MONTGOMERY COUNTY PLANNING DEPARTMENT
THE MARYLAND-NATIONAL CAPITAL PARK AND PLANNING COMMISSION

MEMORANDUM

SUBJECT: 1. Preliminary Forest Conservation Plan: Washington Grove Elementary School Addition – 8712 Oakmont Street, Gaithersburg, R-200 Zone, 1985 Gaithersburg Vicinity Master Plan

2. Mandatory Referral No. 07304-MCPS-1 – Washington Grove Elementary School Addition, 8712 Oakmont Street, Gaithersburg, R-200 Zone, 1985 Gaithersburg Vicinity Master Plan

ATTACHMENT 3

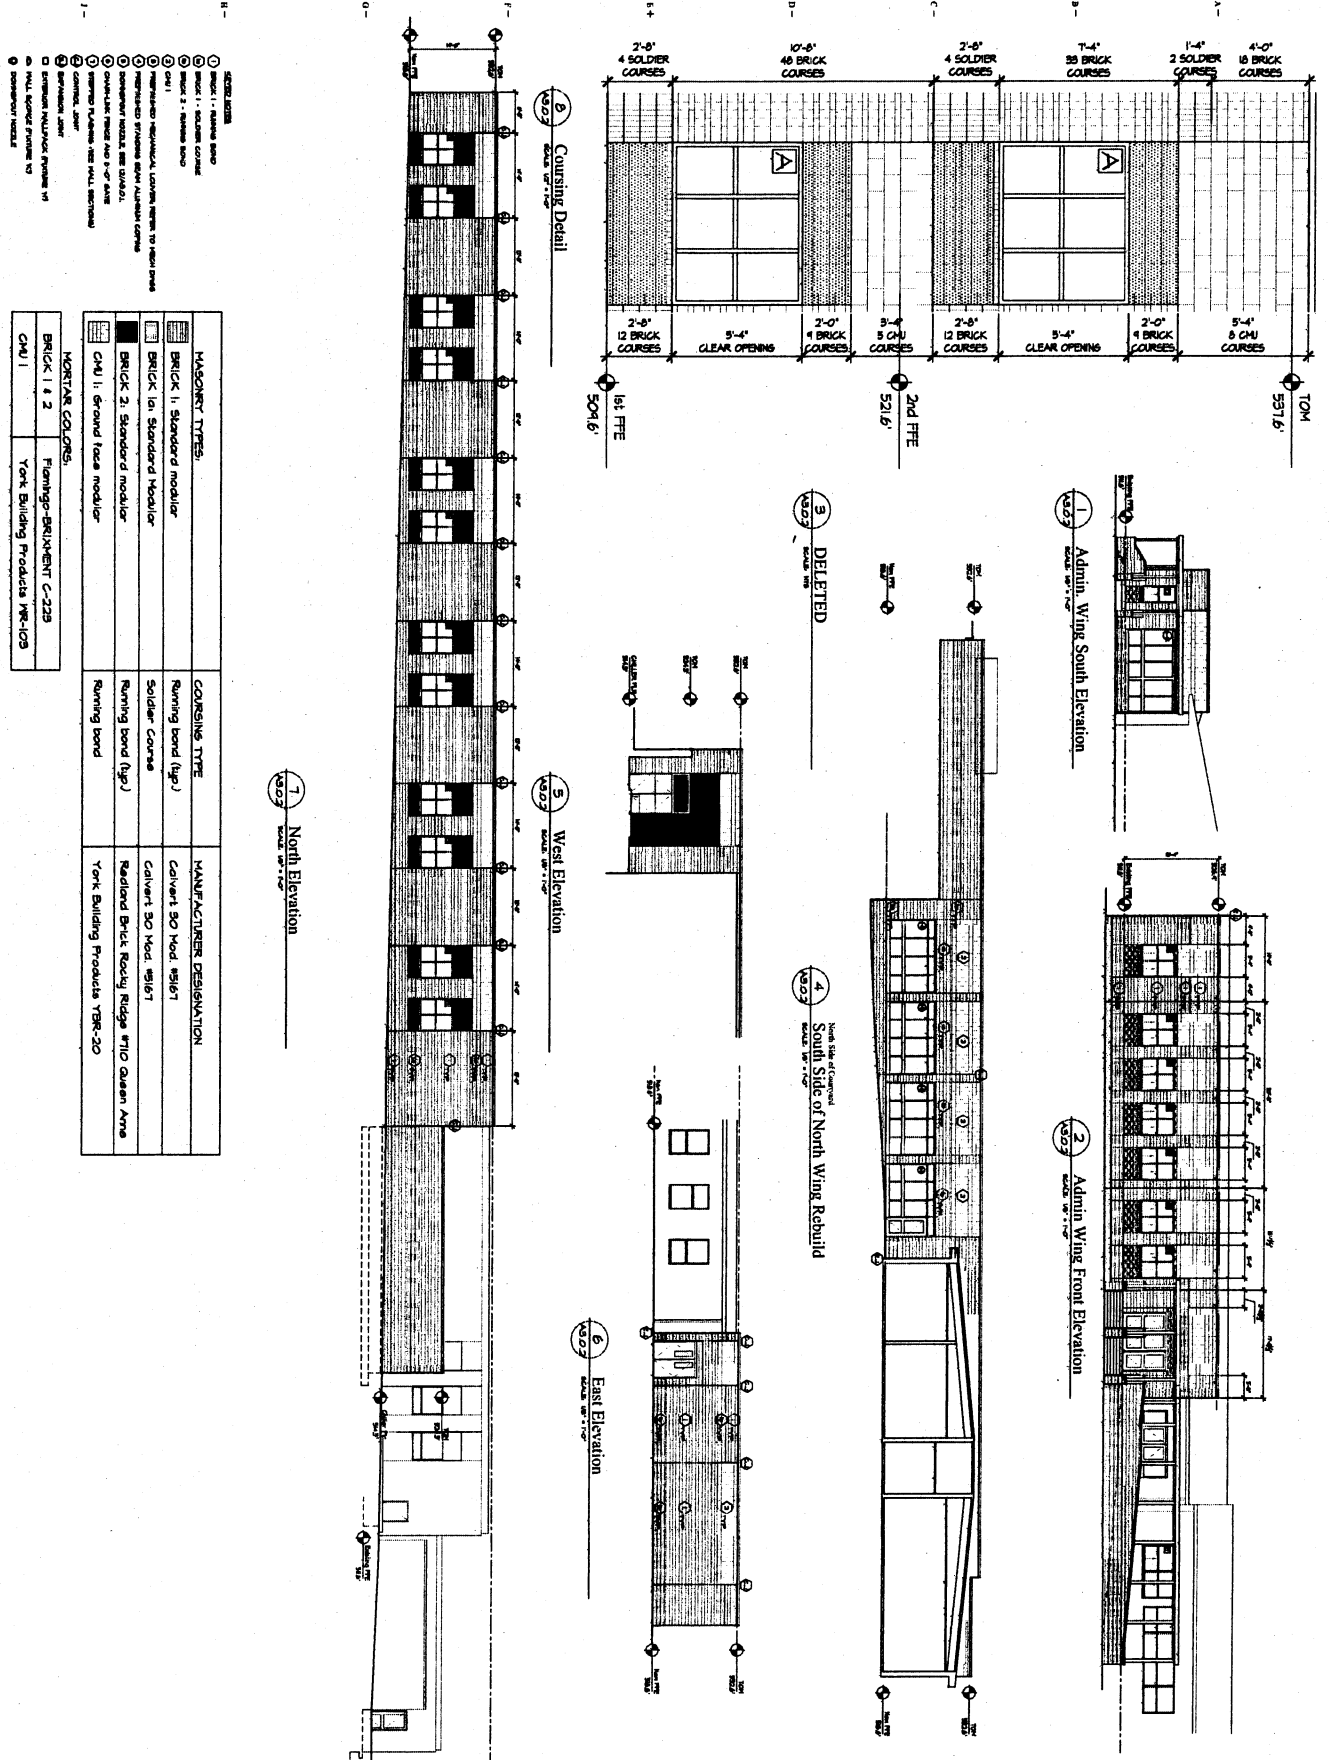
Thanks for the information about the front entrance. I must say that the proposed entrance remains disappointing AND different than what was on the last set of plans with which I was presented. At least the previous plans showed a peaked canopy that made the front somewhat interesting. The proposed entrance looks more to me like a side entrance, rather than a main one...Why was the last proposal changed? Was it too expensive? For the size of this project, I am VERY distressed at this new plan for the front. Is this the very best we can do?

Hi, Ken! I missed seeing you at last night's construction meeting...I was anxious to see a detailed drawing of the new front of the building and was so disappointed to see it looking nothing like I expected...no vault...no peak...nothing at all other than a front door very similar to what we have now. In the preliminary plans, the front looked peaked. I know you and I had talked about a vaulted skylight that you said MCPS would not agree to. But, I felt sure that the new front would show some character...and it doesn't. I did forward an email to you from one of the parents at last night's meeting and one of her issues, as well, was the appearance of the front entrance. Thanks!

- 1) Main entry stair created in place of existing ramp establishes a stronger presence and leads visitor to main entry as opposed to multi-purpose room or gym entry.
- 2) Floor plan steps out to meet the bus loop, projecting the administrative area as a more important feature than current plan.
- 3) Existing classroom windows on front elevation present a horizontal band. The new windows in the administrative suite, along with the contrasting brick detailing and parapet (nearly 4' above the existing roof line) add verticality to the administrative suite.
- 4) Color contrast is provided in the entry canopy, brick detailing, door/frame paint colors.
- 5) Reconfiguring the ramp to the right of the entry allows entry to school without interfering with queuing of students for buses.

ATTACHMENT 8

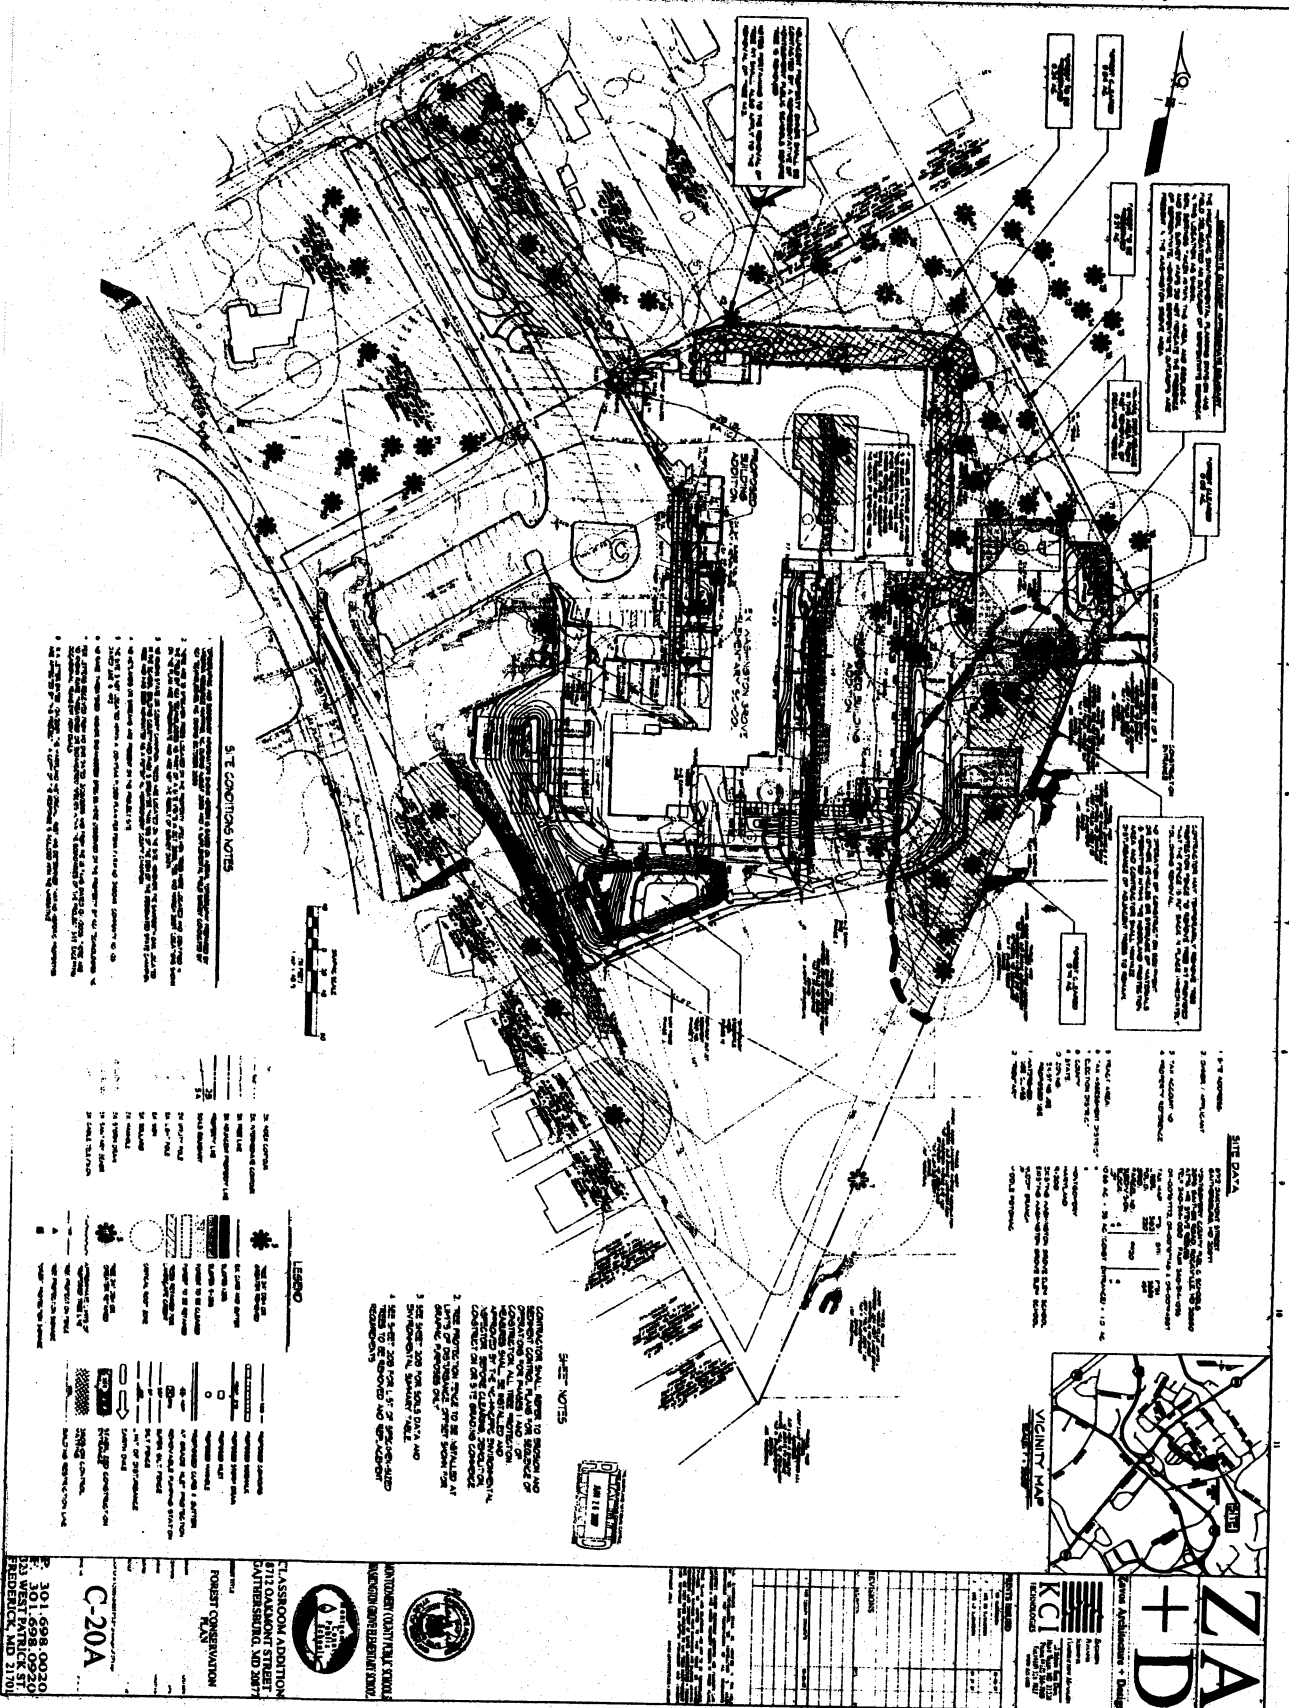
The development has an approved NRI/FSD (No. 420071740 issued April 10, 2007). Staff reviewed the Preliminary Forest Conservation Plan (FCP) submitted for the project. There are 1.85 acres of existing forest on the site. The applicant intends to clear 1.36 acres, which generates a 2.72-acre forest planting requirement. The applicant proposes to meet this requirement by a combination of landscape credit, 0.49 acre onsite forest retention, and contributing 2.18 acres to a suitable offsite reforestation bank. The applicant will meet the requirements of forest conservation law. Staff recommends approval of the FCP with conditions aimed at increasing the amount of retained forest to 1.04 acres.

The school site is located along a seam of Serpentinite that “snakes” its way through the County. Although the rock is not always at the surface as at our Serpentine Barrens Park, it does surface at regular intervals along this seam. The forest on the southeastern part of the school property includes a small (approximately half-acre) area of serpentinite outcrops. The plan shows significant construction work within this serpentinite area. Staff opposes construction in this area for three reasons. First, the

soils in this area are extremely shallow. Our experience with construction on serpentinite is that impacts extend far beyond the actual limit of disturbance. Impacts are increased when blasting is used to alter the grade. The resulting shock waves and fissures affect trees, long distances from the initial impact area. Secondly, the underlying hard serpentinite bedrock at the surface is a limiting factor for tree growth. On such sites, the existing trees need a large area to ensure their survival, react more quickly to disturbance, and new trees (landscaping/afforestation) would be unlikely to thrive. Third, the applicant has not yet taken this impediment into consideration in the construction plan. For financial and safety reasons, the applicant will likely abandon this area as a potential construction site once the implications become apparent. At that point the trees may already be cleared and as mentioned above, be very difficult to replace in this location.

Our recommendations for minimizing tree loss from the site included relocating the fire access road closer to the building, building an 'at-grade' soft play area that did not require grading, combining the fire access road with the sidewalk and hard play area uses, using "grass crete" or other suitable pervious material in access road construction, placing the temporary stockpile area on the existing paved play area near the proposed construction entrance, and eliminating the proposed interior courtyard.

Environmental Guidelines – The site is not within a Special Protection Area or Primary Management Area. Some large trees on a serpentinite outcrop at the eastern part of the property that the applicant proposes to remove can be saved.

1. Submit a Final Forest Conservation Plan that meets the requirements of Section 109(B) of the Forest Conservation Regulation. Final FCP to be approved by the M-NCPPC prior to any clearing or grading for the facility.
2. Avoid the area shown as serpentinite outcrop, in the eastern portion of the site, and take extraordinary measures to protect forest and large trees in that area.
3. Submit a Final Landscape Plan to staff for review.
4. Protect tree number 42 by minimizing grading off the northern wing of the building, and tree number 19 by using appropriate measures to protect its critical root zone from construction traffic.
5. Place all forest credited for retention in a Category 1 conservation easement.
